Name Of Dam: SWIFT CREEK RESERVOIR DAM
Location: CHESTERFIELD COUNTY
Inventory Number: VA. 04112

PHASE I INSPECTION REPORT
NATIONAL DAM SAFETY PROGRAM

DEWARD M. MARTIN & ASSOCIATES
WILLIAMSBURG, VIRGINIA

AUGUST, 1979

STABILITY	ANALYSIS
CASE NO	FACTOR OF SAFETY
I	2.0
III	1.5

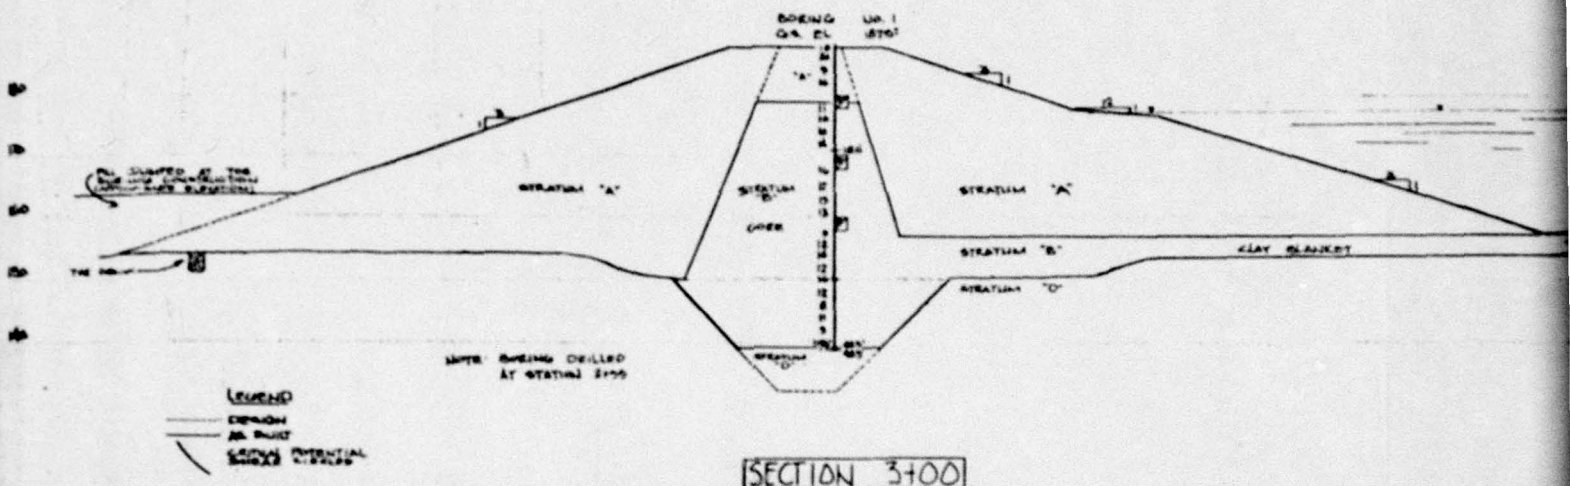
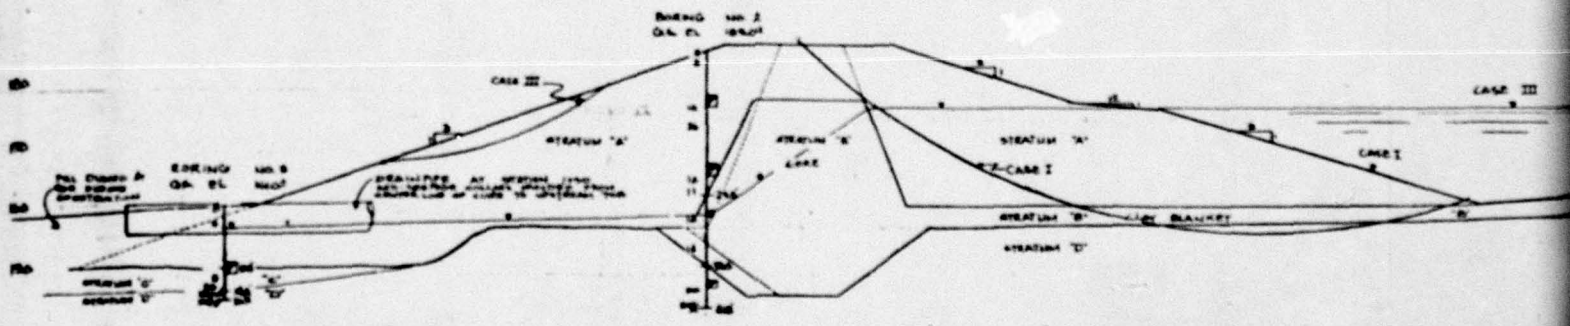
It should be noted in Drawing 3 that the critical failure circle for Case I loading conditions goes through Stratum D. There was no laboratory data presented for Stratum D and it is highly unlikely a critical failure would occur in this very dense material weathered rock rather than in the Stratum B soils (clay blanket) above it.
